**RE: November 3, 2021 Meeting  
64 Vaughan Mall Restoration  
Portsmouth, NH 03801**

Attention: Historic District Commission  
RE: 64 Vaughan Mall (LU-20-214)

**Re: 64 Vaughan Mall**  
***East Wall of existing building***

2nd Floor  
perspective of floor  
assembly &  
masonry wall  
(North East  
Facade) pulling  
away. Heavy  
timber beam  
degraded and  
having little bearing

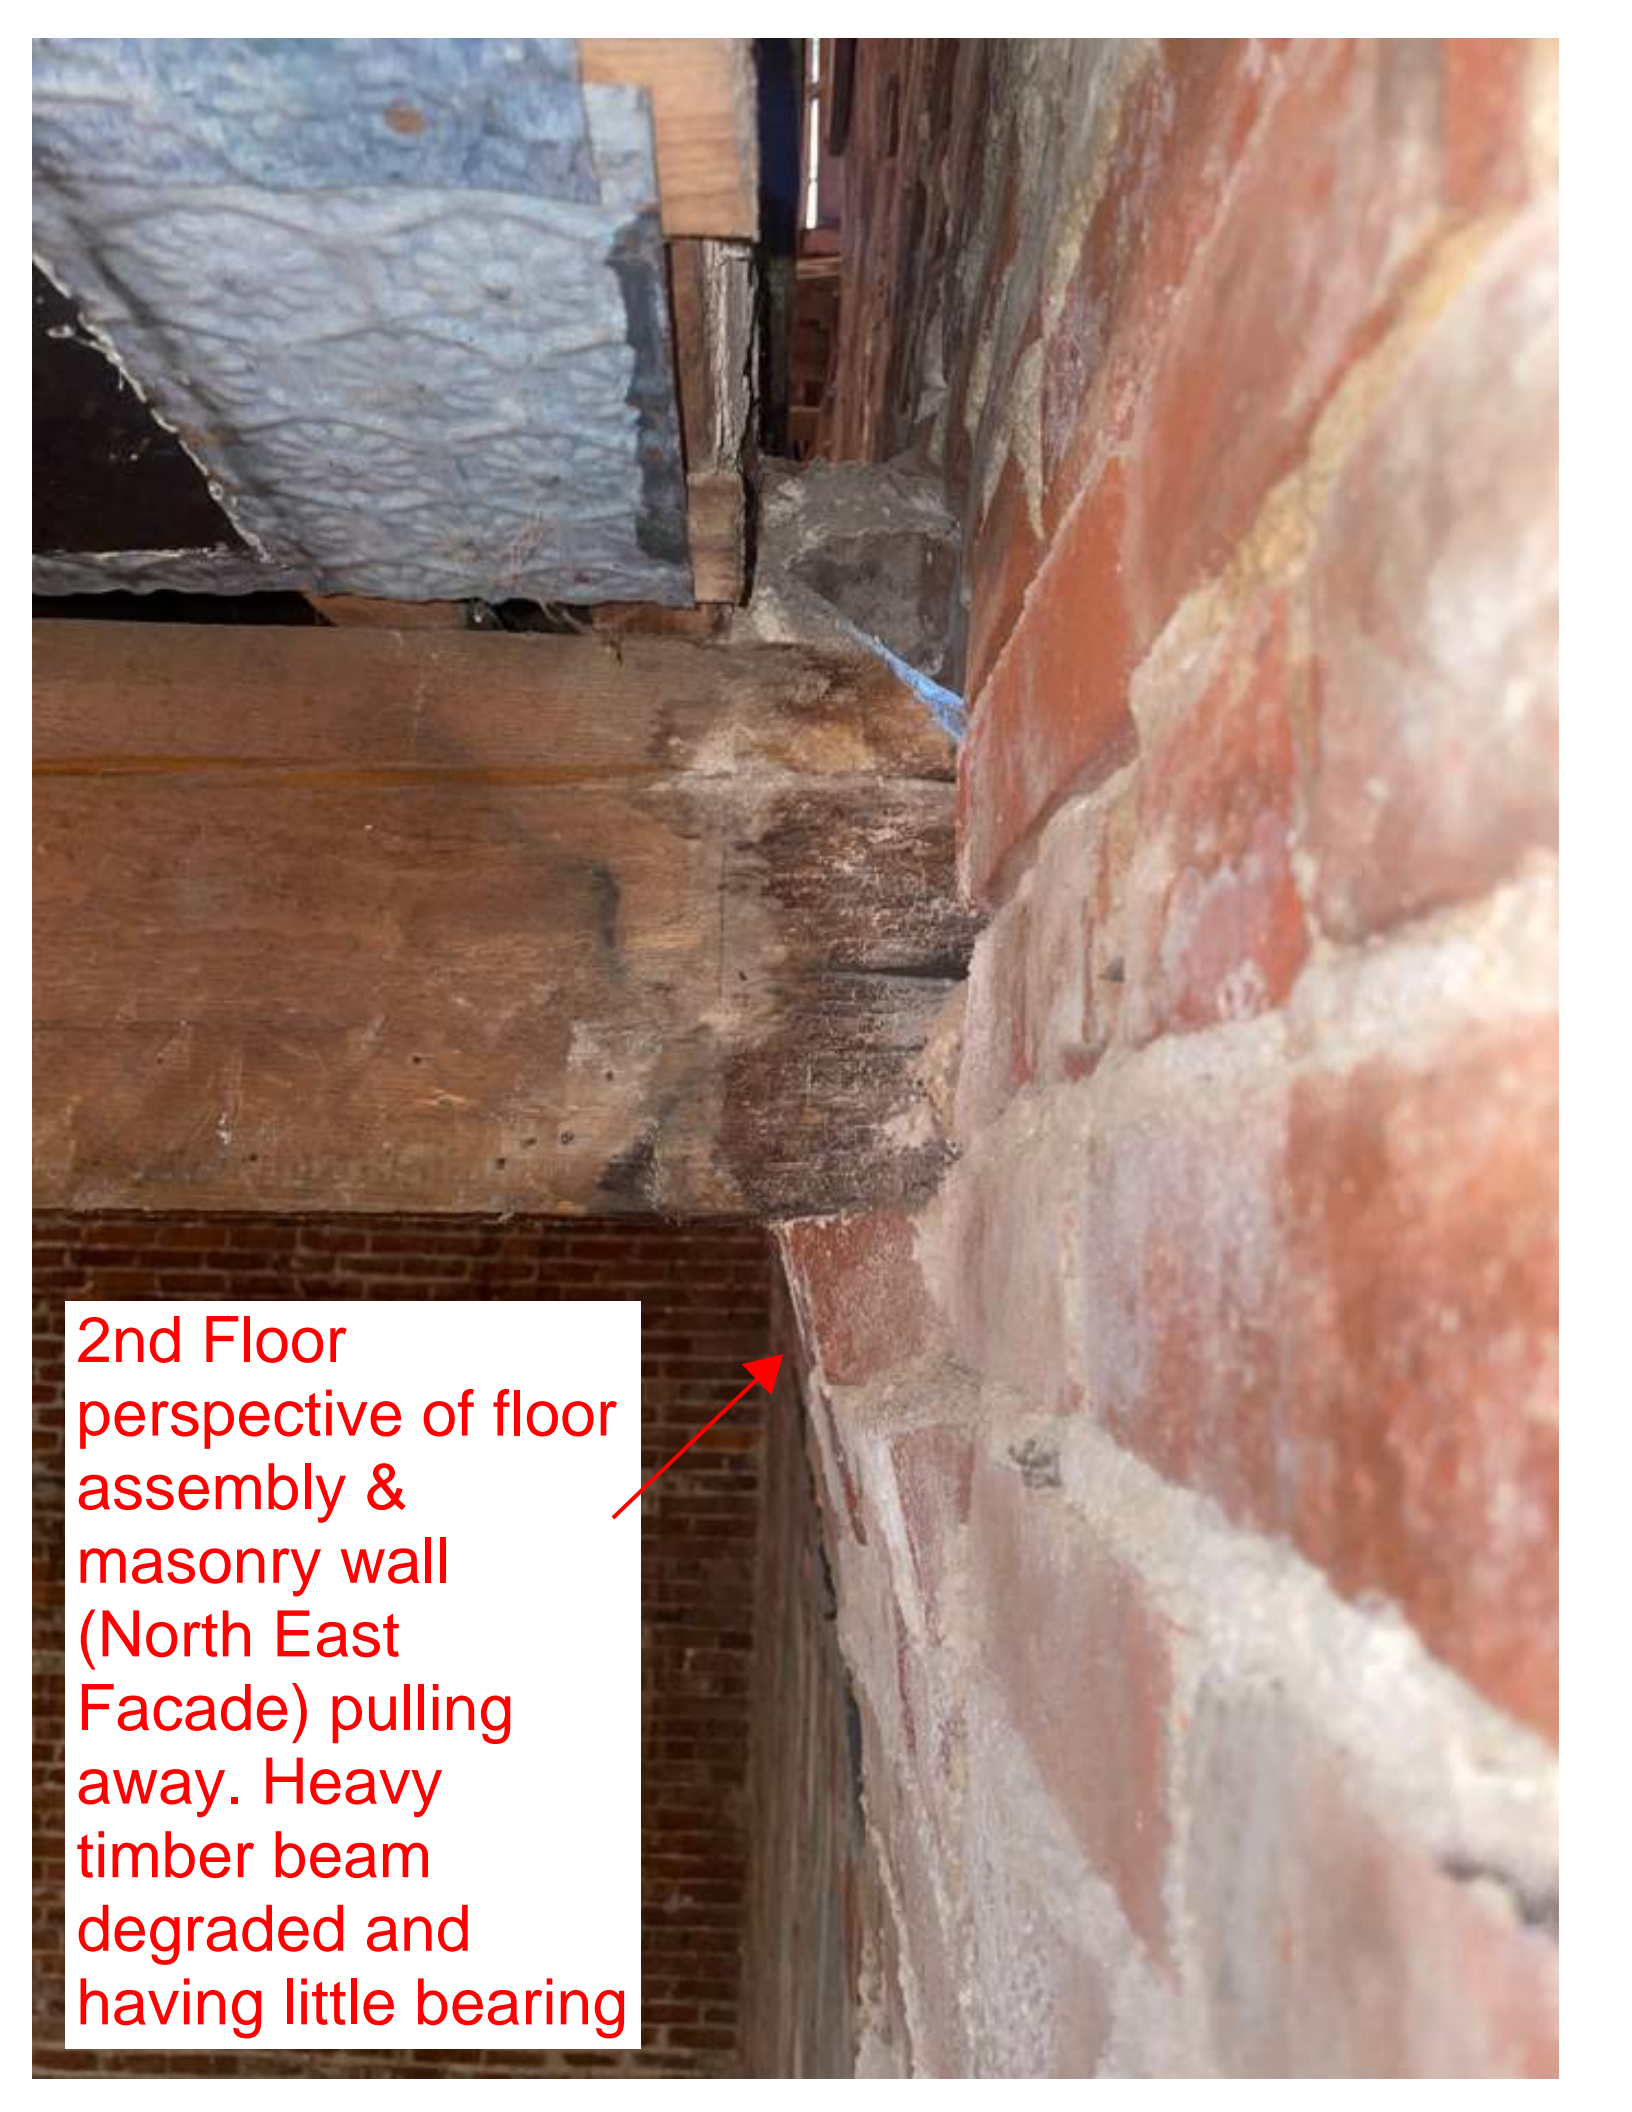
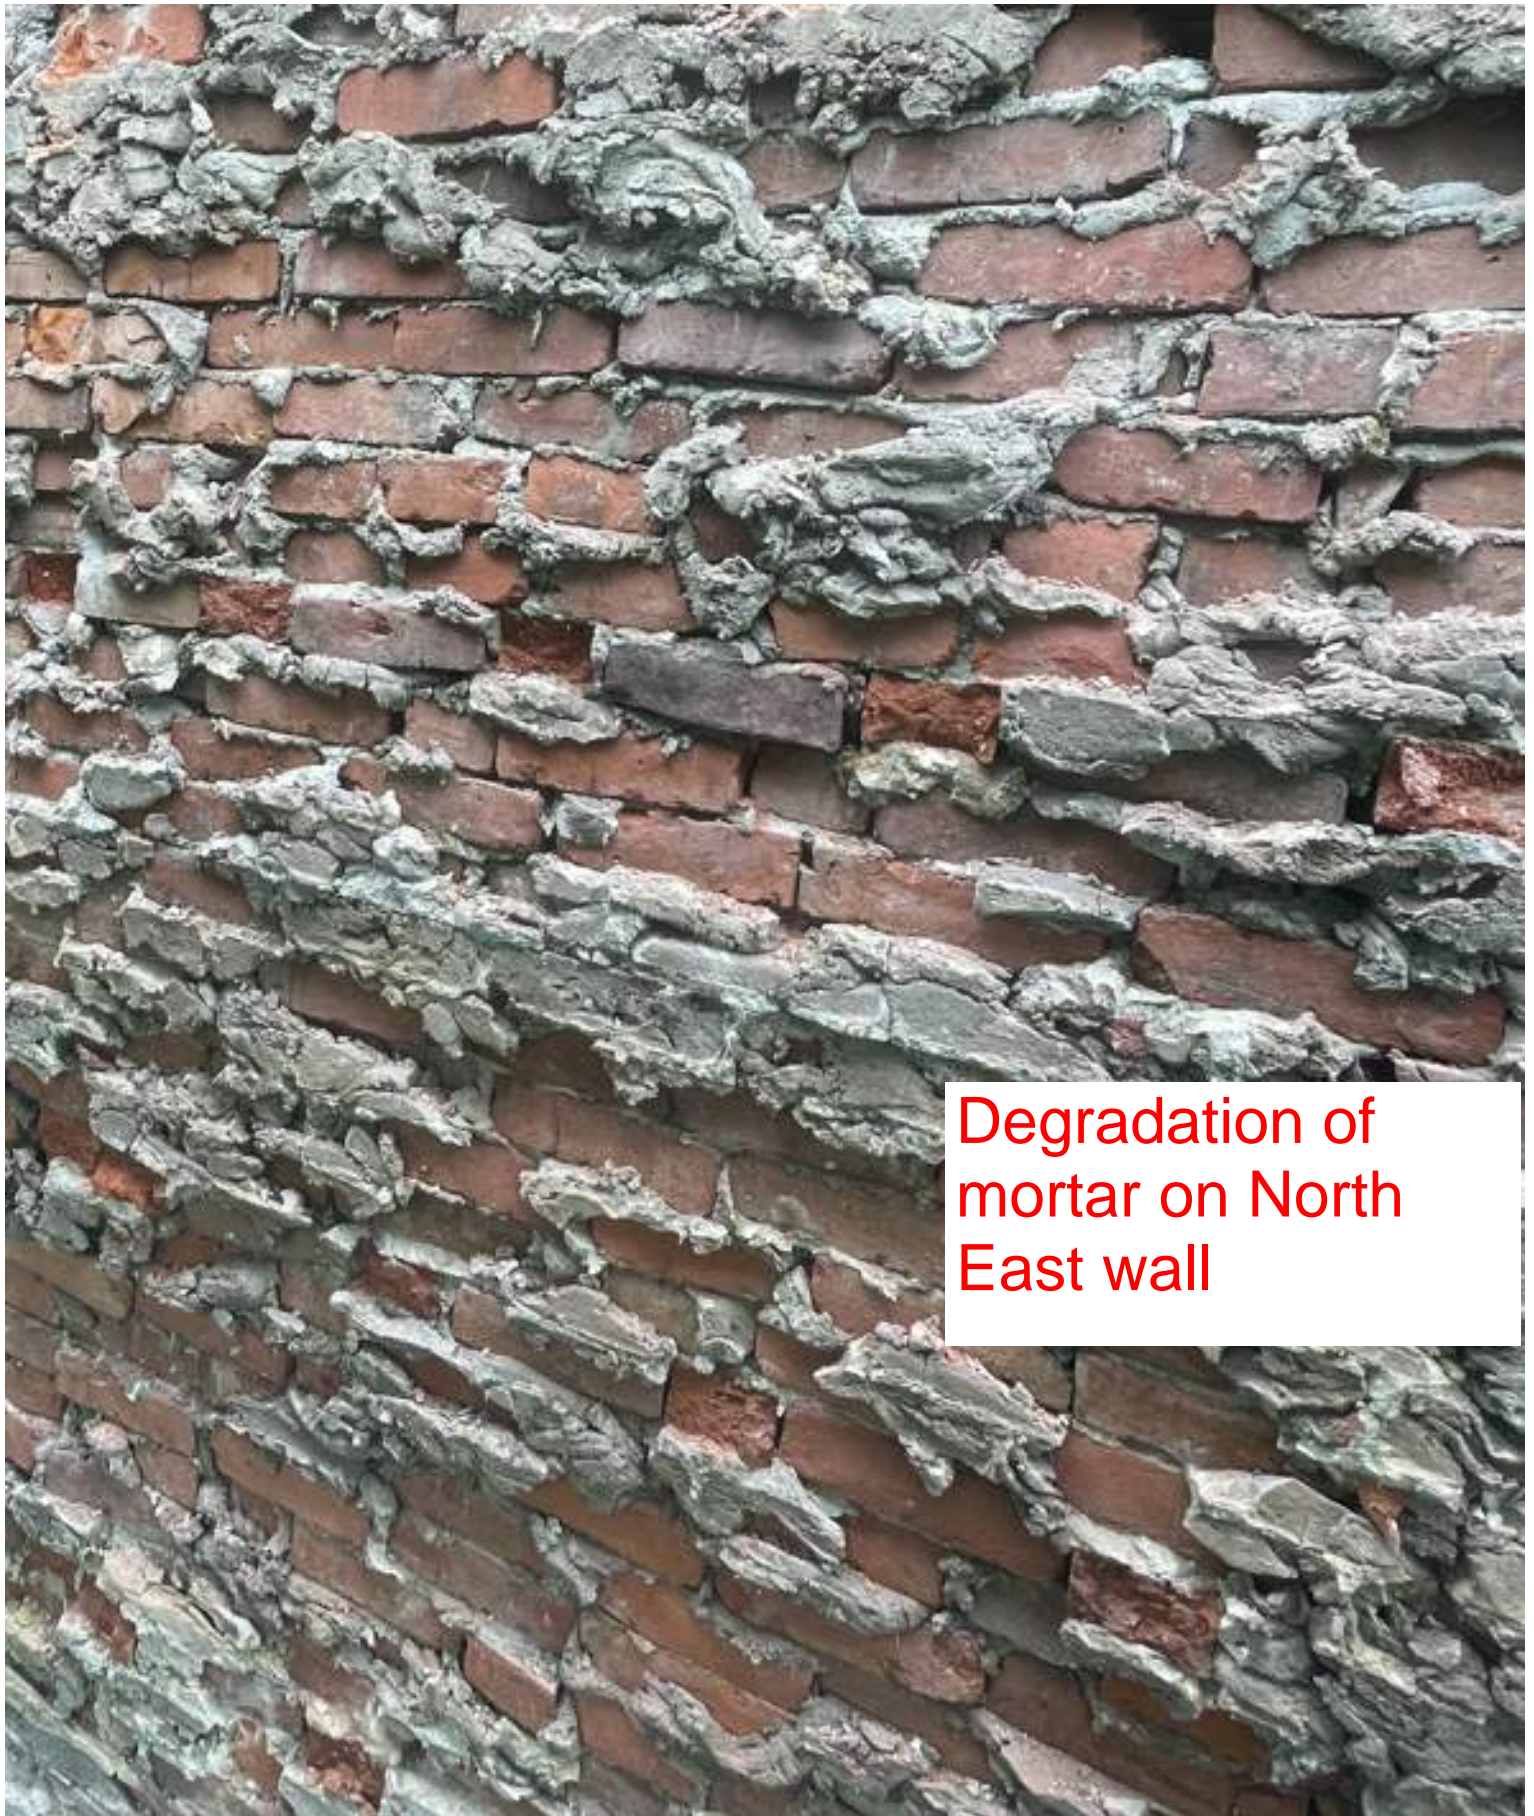
This letter is specifically regarding the existing East wall. This wall is a storefront at street level and a 12" brick wall with windows above. There are serious structural concerns with the north half of this wall. First, from the inside we noticed this brittle unreinforced brick wall has bowed outward approximately 3" and the beam penetrating and bearing on it has very little bearing. As you started to remove the outer wythe from the top down, we further discovered the poor quality and degradation of the wall. Interior joints are poorly mortared with many openings in joints, meaning there is not much effective "glue" holding it together. In addition, we have found some of the steel lintels are severely corroded. This renovation is timely as a structural collapse of this wall was certainly a risk.

Due to the large bow of the wall, and the additional construction quality and deterioration issues, I would strongly advise removal and replacement of the East wall.

## Brick Samples - 64 Vaughan Mall

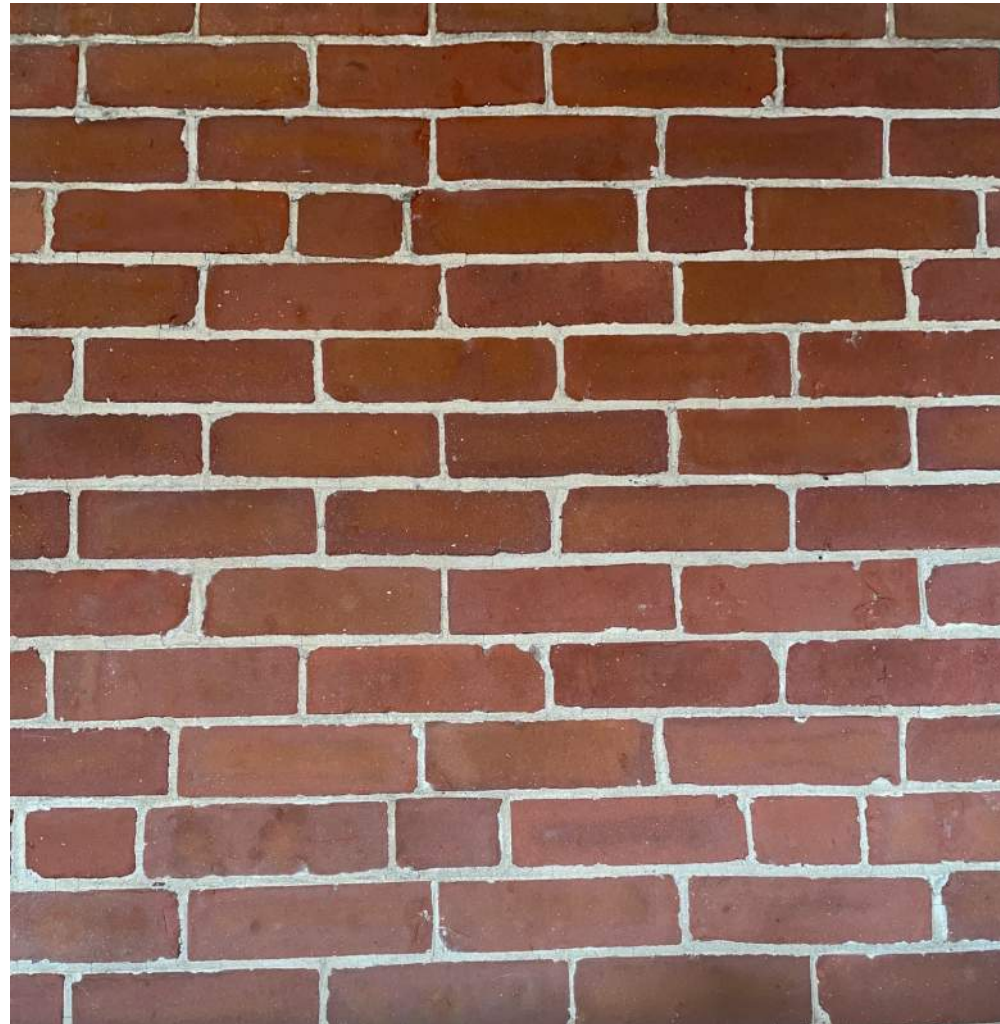
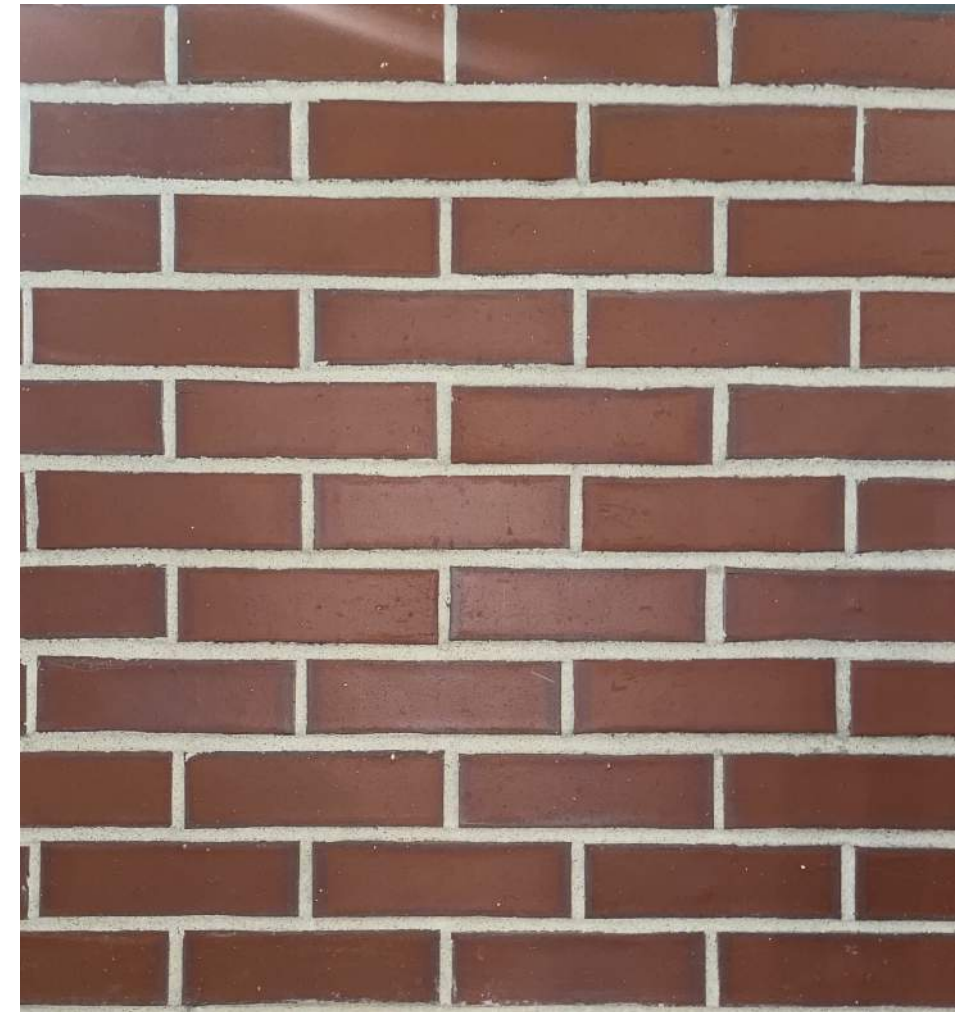
- Revisit the approved brick, Morin Semi-Smooth, Light Flashed, Narrow Range Veneer. Based on a sample 'mock-up' of the approved brick the applicant would like to explore a closer match to the existing historic brick. Additionally, after exploratory select demolition of the East Elevation, and the visual appearance of thin brick veneer, the applicant proposes to use a full wythe brick for the reconstruction of the East & South elevations.
- Discuss the abandonment of the recessed balconies on the Vaughan Mall and maintain the historic façade as it was when the building was originally constructed
- Incorporate a tasteful skylight on the flat roof, located at the core of the building
